Contract #: 04-0120F4Cty: SF/ALA Rte: 80 PM: 13.2/13.9File #: 69.25B**QUALITY ASSURANCE -- NON-CONFORMANCE REPORT****Location:** Changxing Island, Shanghai, PRC**Report No:** NCR-000347**Prime Contractor:** American Bridge/Fluor Enterprises, a JV**Date:** 31-Jul-2009**Submitting Contractor:** Zhenhua Port Machinery Company, Ltd (ZPMC), Changxing Island**NCR #:** ZPMC-0321**Type of problem:**

Reference Description: Excessive weld pass width on South Tower, Lift 3, AE corner seam weld**Description of Non-Conformance:**

Dear: Mr. Charles Kanapicki
Job Name: SAS Superstructure

Subject: NCR No. ZPMC-0321

eWELD NUMBER: SSTL3-1B/K-84A/B

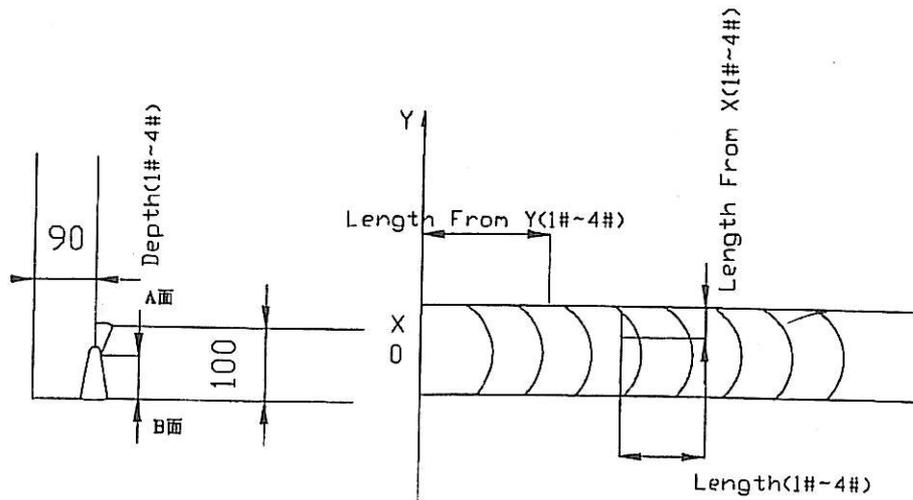
Rejected indication found by ultrasonic inspection at third time.

1. 焊缝的位置比较狭窄, 碳刨时, 不能准确的将缺陷刨出.
 2. 打磨工在打磨时, 不够仔细, 没有将所有的缺陷去除.
1. The access space was quite narrow resulting in making it difficult to arc-gouge the defects effectively.
 2. The grinder was not observant during the grinding operation resulting in the indications not being completely removed.

1. QC shall monitor and direct the welder and the grinder doing the repair operation.
 2. Preheat before gouging; the temperature shall be at least 65°C.

3. Gouge the weld to remove identified defects.
 4. Joint details shall refer to the approved WPS repair.
 5. Grind the gouged areas to a smooth and shiny surface.

6. Verify with VT and MT to ensure no defects remain in the weld joint prior to welding.
 7. QC shall monitor all welding passes being deposited.
 8. QC shall ensure all slag has been removed prior the deposition of next pass.

9. Preheat and maintain interpass temperature control in accordance with the WPS.
 10. Blend the weld repaired areas into the adjacent weld or base metal by grinding.

11. Perform VT, MT and UT NDT inspection to the repaired areas.
1. 在返修过程中, QC 应该监控和指导焊工和打磨工;
 2. 碳刨之前必须先进行预热, 温度不低于 65°C;
 3. 碳刨去除缺陷;
 4. 缺陷被完全清除后, 必须准备一个正确的接头型式, 具体接头型式请参见对应的修补焊接工艺规程(WPS);
